**Comhairle Chontae Chill Chainnigh
Kilkenny County Council
Planning Report**

Planning Ref: 26/60217
Due Date: 08/06/2026

Applicant: Martin Campion
Subject: Retention Permission sought for 3nr modular garden studios consisting of two domestic one bedroom homes and home office for domestic use as constructed and permission for foul drainage system and percolation area and all associated works at Threecastles, Co. Kilkenny.

Fig 2 – Site layout

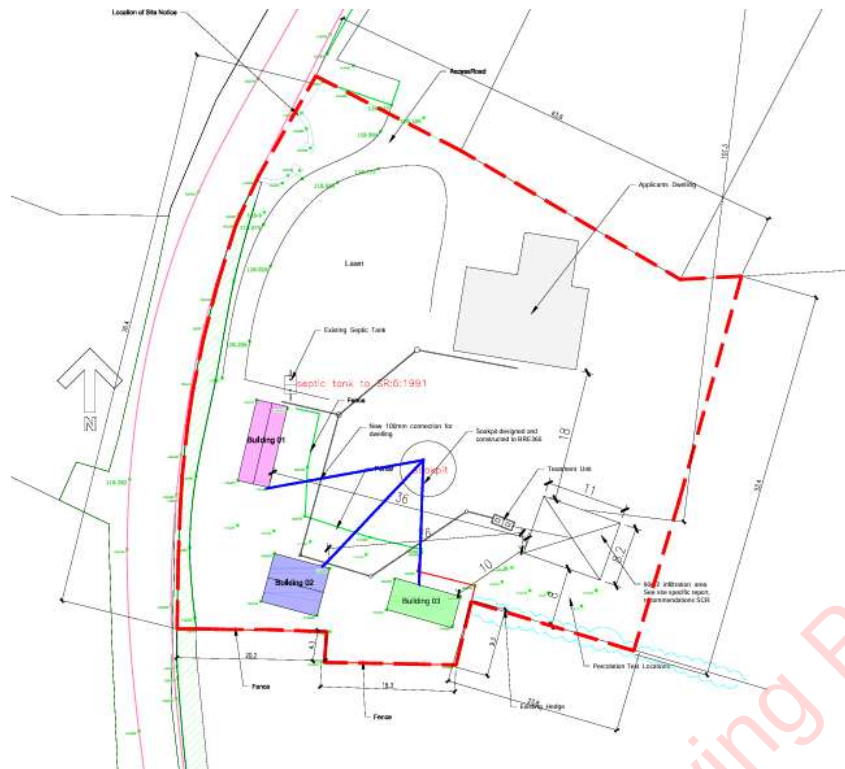
From site inspection it is noted that the only vehicular access to the site is located at the northern site boundary via an existing hard surfaced car park area which appears to form part of the neighbouring 'Campions' public house to the north of the car park area. This entrance does not comply with therefore unauthorized.

It is further noted that the parent permissions on site included for the provision of a septic tank and percolation area. Buildings 02 and 03 appear to be located in the area previously indicated as the percolation area. Consequently, the existing two storey dwelling house development on site is not in accordance with the permission granted under P03/1629 and 06/242.

The application documents indicate that a new wastewater treatment unit with soil polishing filter is proposed on site. It is noted the site layout drawing indicates an infiltration area.

The site layout indicates the location of an existing septic tank located to the south west of the existing two storey dwelling house on site. No percolation area has been indicated. It is noted from the parent permission on this site, P. 03/1629 and P. 06/242, that a septic tank and percolation area were to be provided in the vicinity of the currently 3no. unauthorized structures on site. It would appear therefore that the dwelling house development permitted under P03/1629 and P06/242 is not planning compliant.

Fig 3 – Plans and elevations of 3no. modular structures

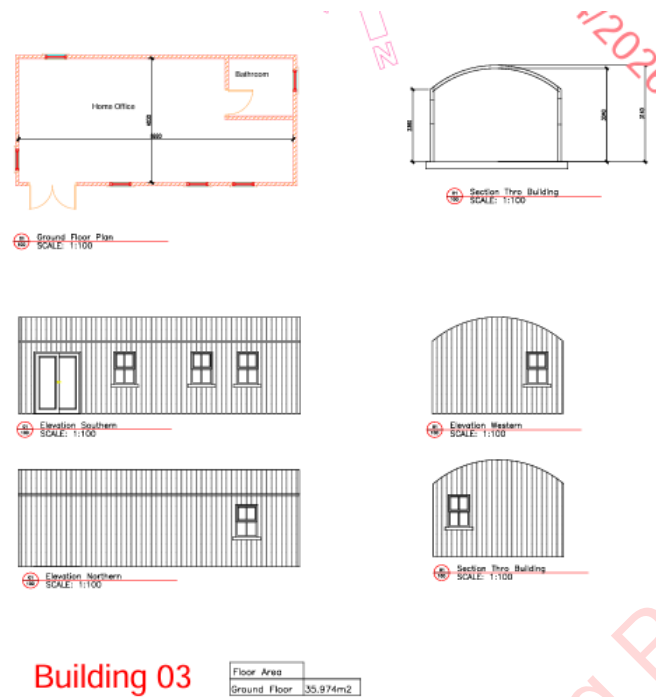
- Building 01 is occupied by the applicant's brother (49sqm) One bedroom
- Building 02 is occupied by the applicant's daughter (42sqm) One bedroom
- Building 03 is used as a home office.

It is stated that Building 02 has been in place since 2017.

No details are included as to the use of the domestic home office on site. It is unclear if this is ancillary to the existing two storey dwelling on site or if it is associated with one of the unauthorized modular homes.

Fig 4 – Site layout as permitted under P06/242 for two storey dwelling on site

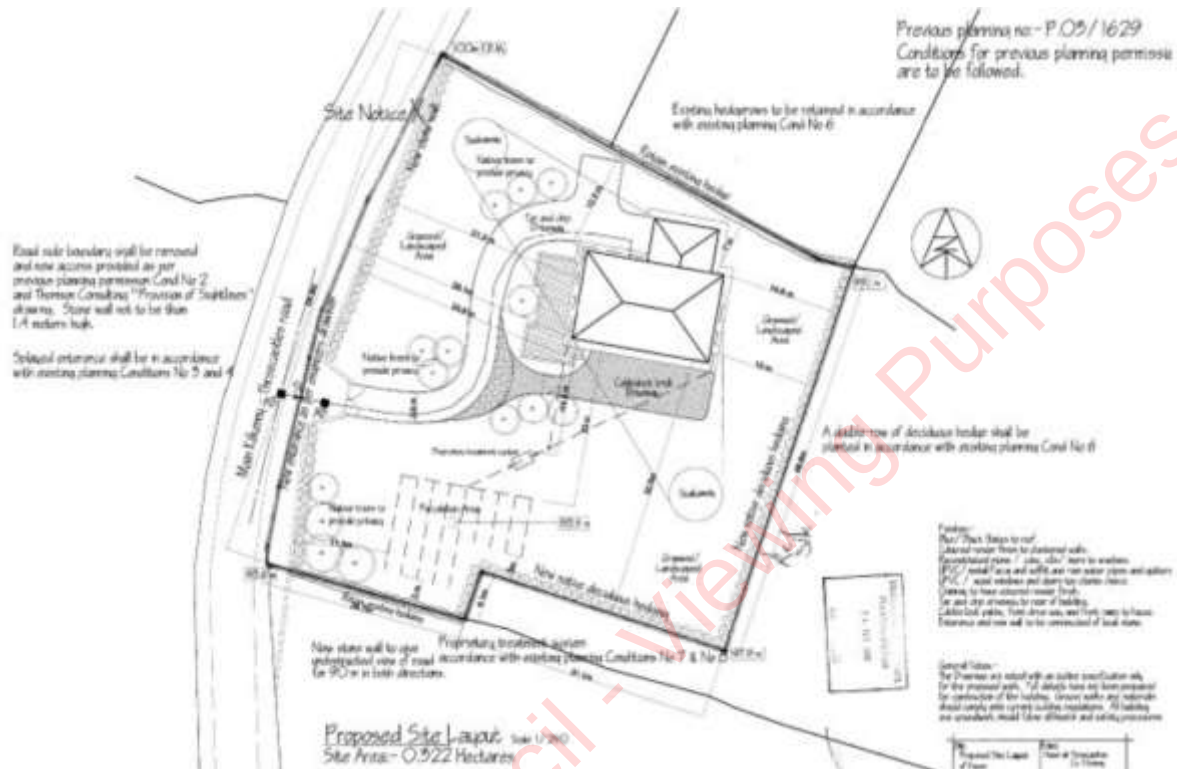
The parent permission/s on this site includes for a vehicular entrance to be provided to the western site boundary, directly onto the L1825, as indicated on the site layout drawing above at Fig 4.

The site is currently not accessed directly off of the local road L1825. The entrance to the site is located along the northern site boundary and is accessed via an existing hard surfaced car parking area, which appears to serve the neighbouring public house to the north. This is contrary to the conditions of the parent permission/s on this site.
